SUBJECT: Forwards Rev 1 to 8930414 response to NUREG-0737, Suppl 1,  
 consisting of proposed changes to operational schedules for  
 safety parameter display sys & upgraded meteorological sys.

Subject: Duke Power Company  
Oconee Nuclear Station  
Docket Nos. 50-269, -270, -287

Response To Supplement 1 To NUREG-0737  
Document Revision Transmittal

Revision Number 1

FIGURE 2-2  
 OCONEE NUCLEAR STATION  
 UNITS 1, 2, 3

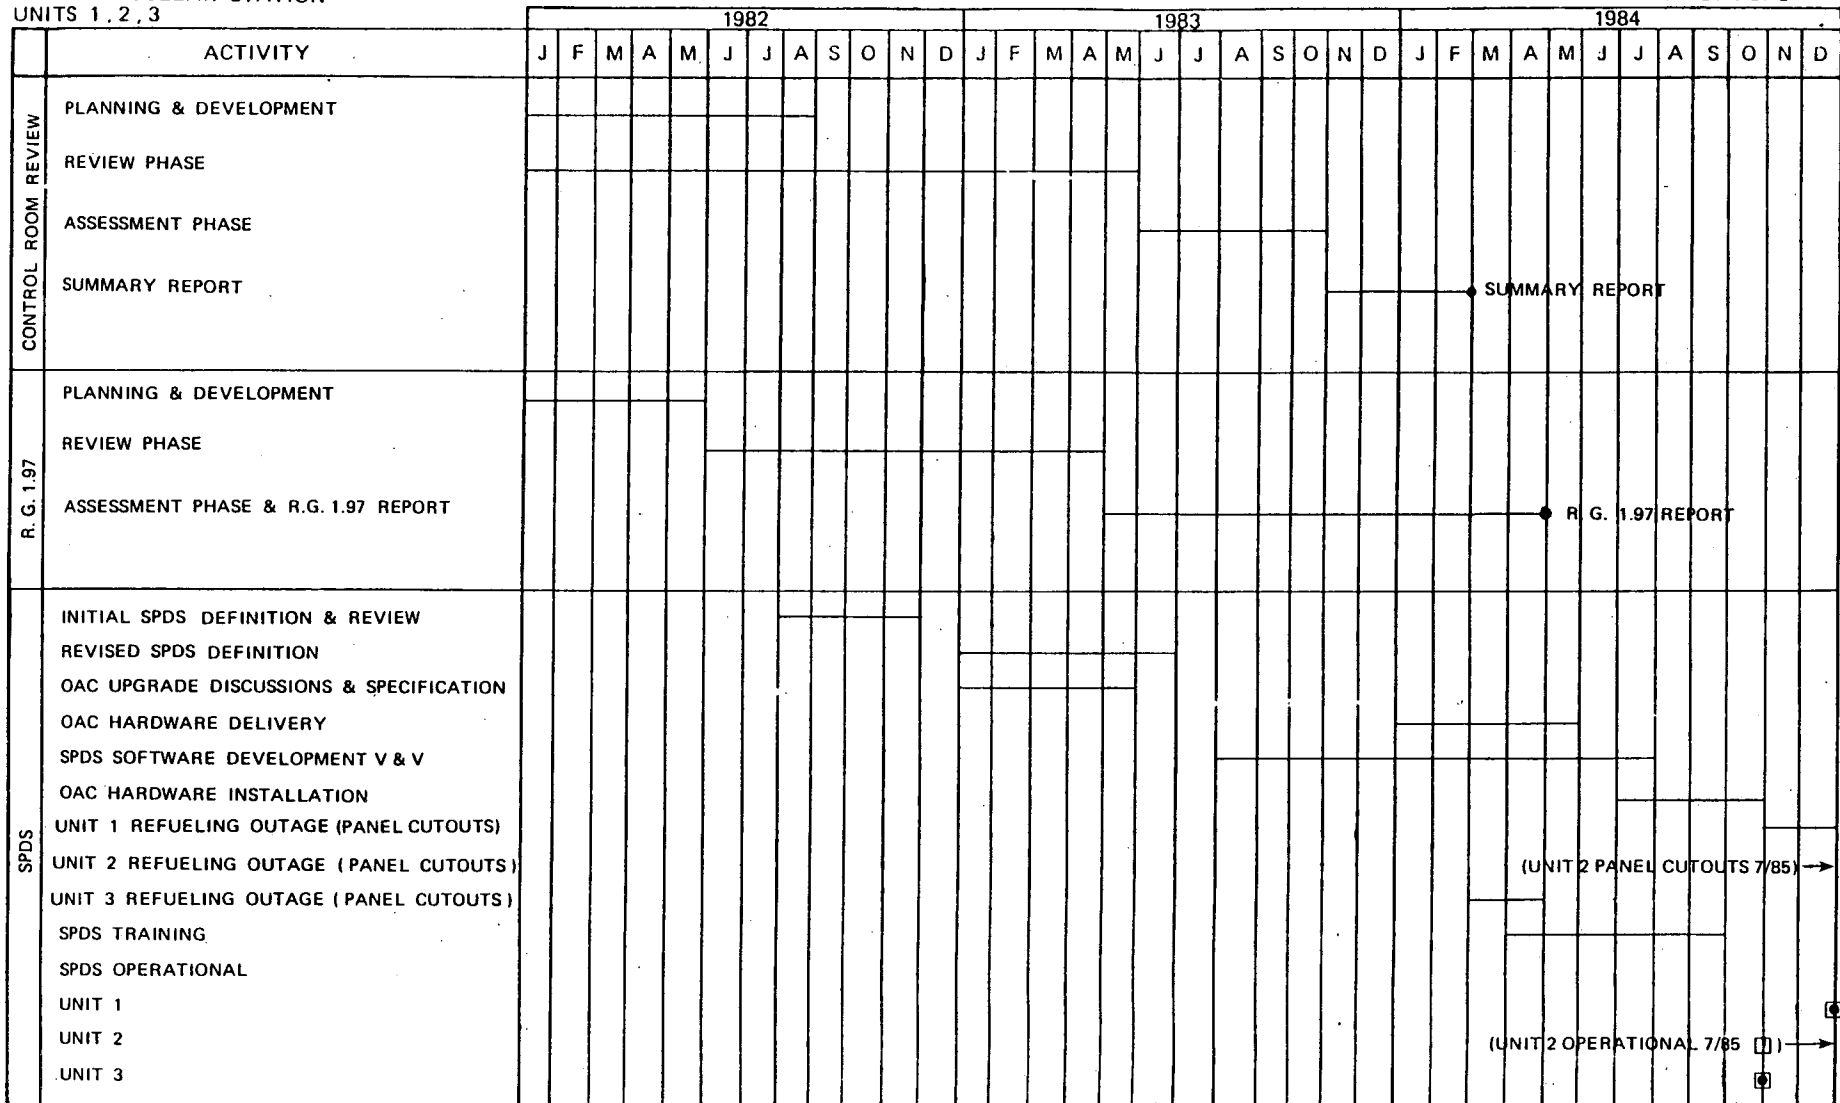
Revision 1 consists of proposed changes to the operational schedules for the Safety Parameter Display System (SPDS) and the Upgraded Meteorological System at Oconee Nuclear Station.

The revised SPDS schedule affects only Oconee Unit 2 and is required because of our projected inability to complete the control board modifications required to facilitate SPDS installation during the upcoming Unit 2 refueling outage (currently scheduled to begin on September 16, 1983). Specific factors for consideration are:

panel cutouts and because of possible interference with operational activities Duke Power feels it is undesirable to perform this work while the unit is operating. Alternatively, it is proposed that all the Unit 2 SPDS installation activities be completed during the following refueling outage (approximately May, 1985) thereby creating an operational date of July 1985 for the Oconee Unit 2 SPDS.

The operational date for the Upgraded Meteorological System at Oconee Nuclear Station was submitted as January, 1984 and is now being proposed as May 1984. This additional time is required to allow completion of a new Class A dose calculation model being developed for Oconee.

Insert Figure 2-2  
Sheet 1 of 2, Rev. 1
